# Attachment 4

Response to  
DAWE Advice

## WINCHESTER SOUTH PROJECT

Environmental Impact Statement  
**Additional Information**

**Figure A4-2a**

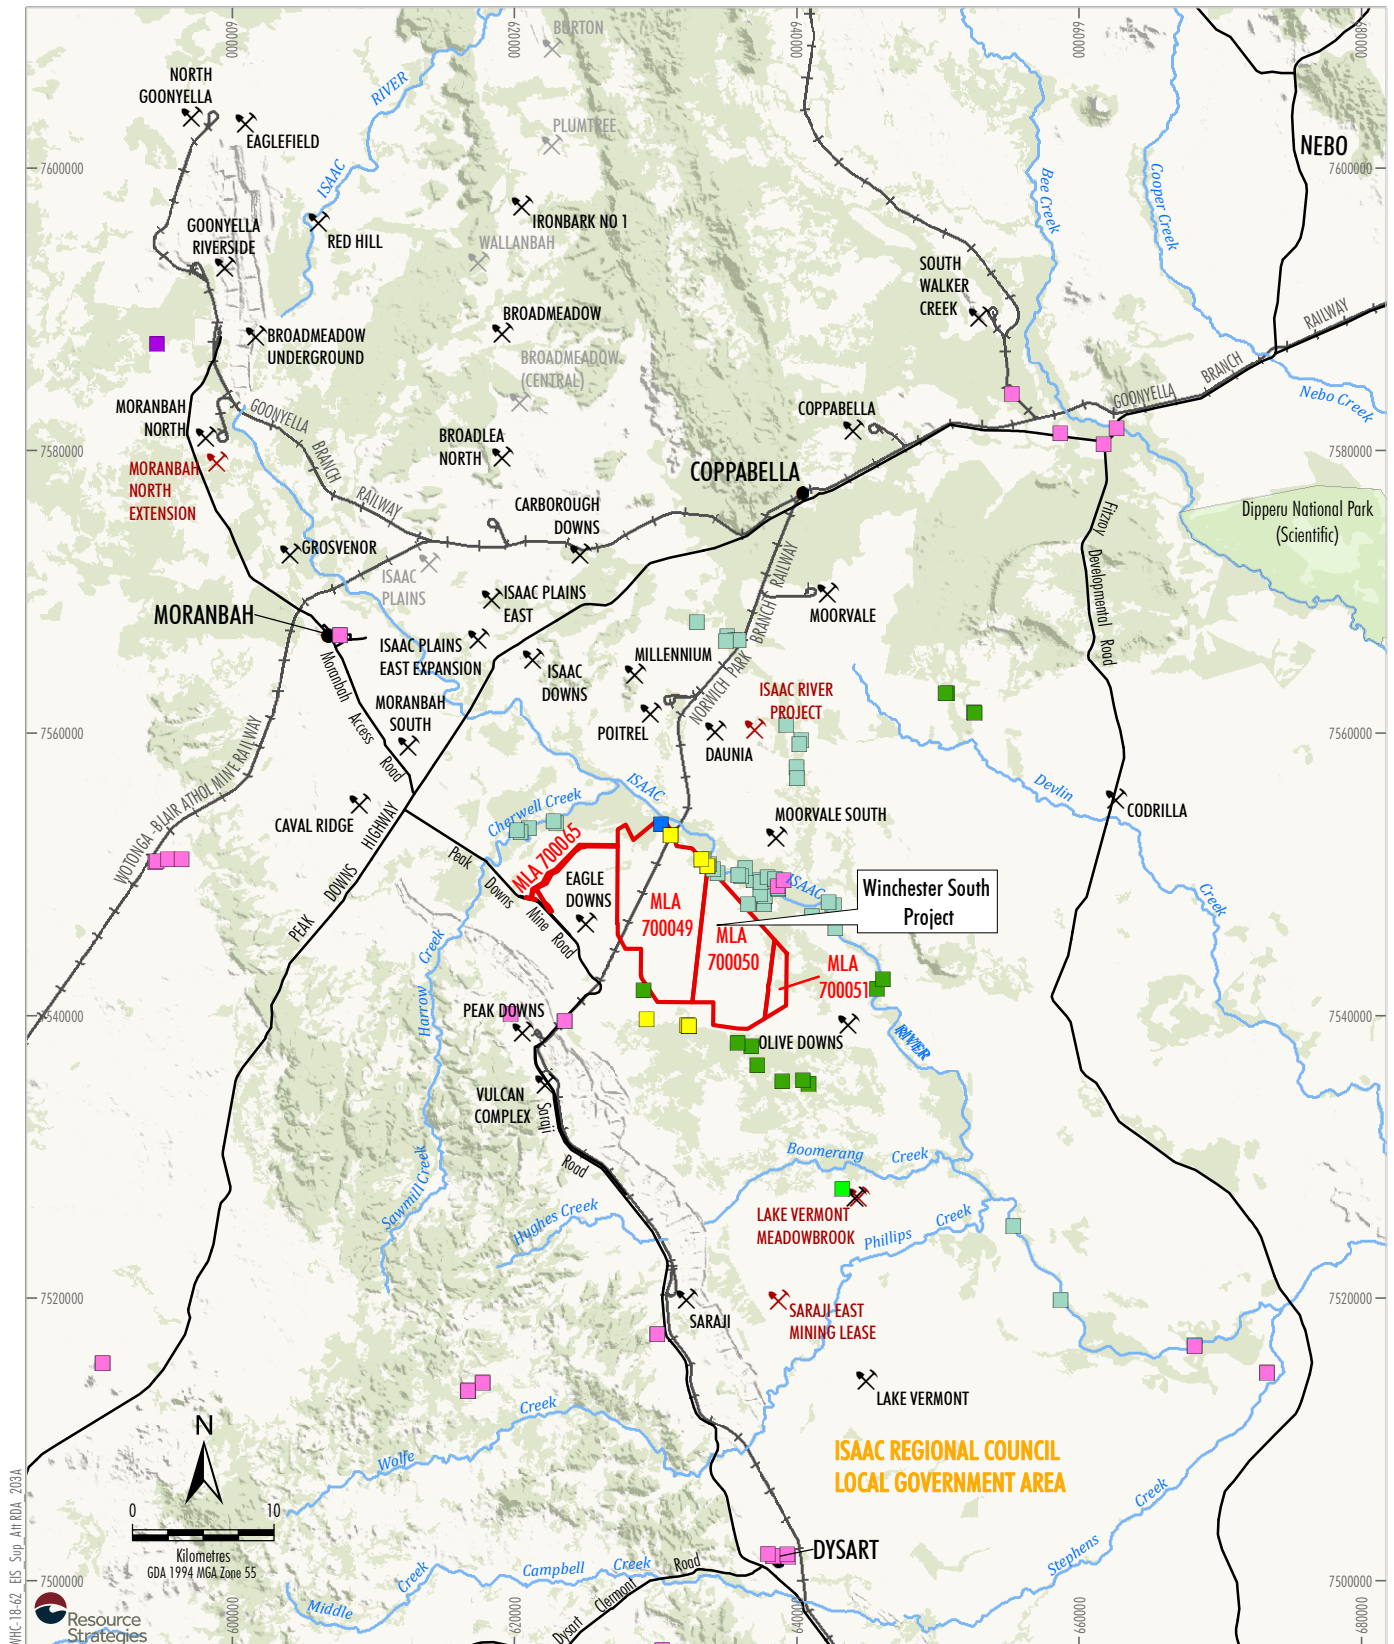
DAWE requested clarification on the Koala (combined populations of Queensland, NSW and the Australian Capital Territory [ACT]) (*Phascolarctos cinereus*) and Greater Glider (*Petauroides volans*) records shown on Figures 5-7 and 5-12 of the Draft EIS. In addition to this, DAWE requested changes to Figure 5-9 of the Draft EIS to distinguish mapping areas.

The data on Figures 5-7 and 5-12 of the Draft EIS match, however some of the symbols overlap. To improve the clarity of the records, Figure 5-7 of the Draft EIS has been split into two separate figures (Figure A4-2a and Figure A4-2b), showing threatened species records of the Greater Glider and Koala (combined populations of Queensland, NSW and the ACT), respectively.

**Figure A4-4a**

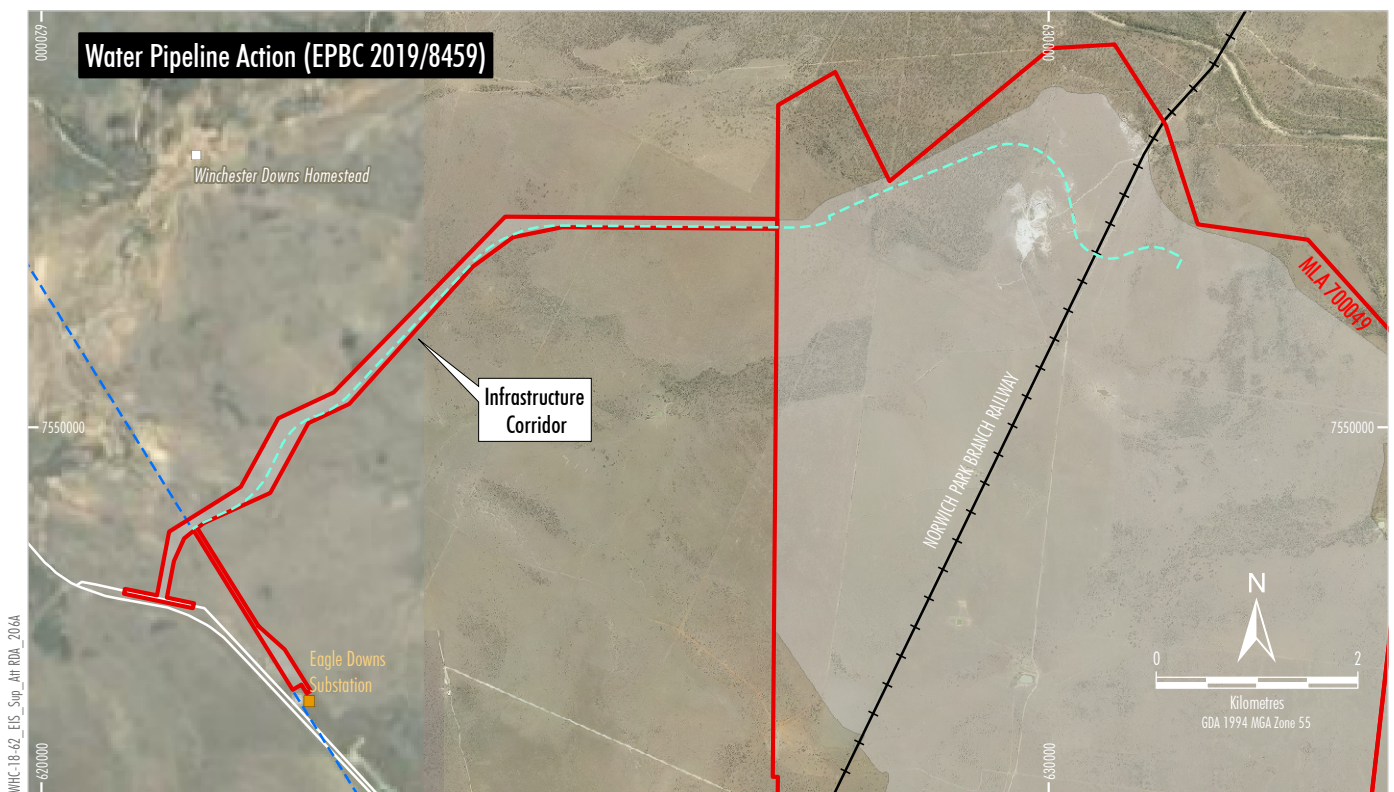
DAWE requested that all disturbance associated with the Project be allocated to the Mine Site and Access Road Action [EPBC 2019/8460].

DAWE requested separate figures for each of the Proposed Actions that comprise the Project (Mine Site and Access Road Action [EPBC 2019/8460], Electricity Transmission Line (ETL) Action [EPBC 2019/8458] and Water Pipeline Action [EPBC 2019/8459]).

All associated Project disturbance has been allocated to the Mine Site and Access Road Action [EPBC 2019/8460] as shown on Figure A4-4a. This approach is consistent with Attachment 7 of the Project Additional Information (Offset Management Strategy).

Additional figures have been prepared to separately show the individual actions (Figures A4-4a and A4-4b). It is noted that the impacts in relation to the ETL and Water Pipeline Actions will be significantly reduced by co-locating this infrastructure.
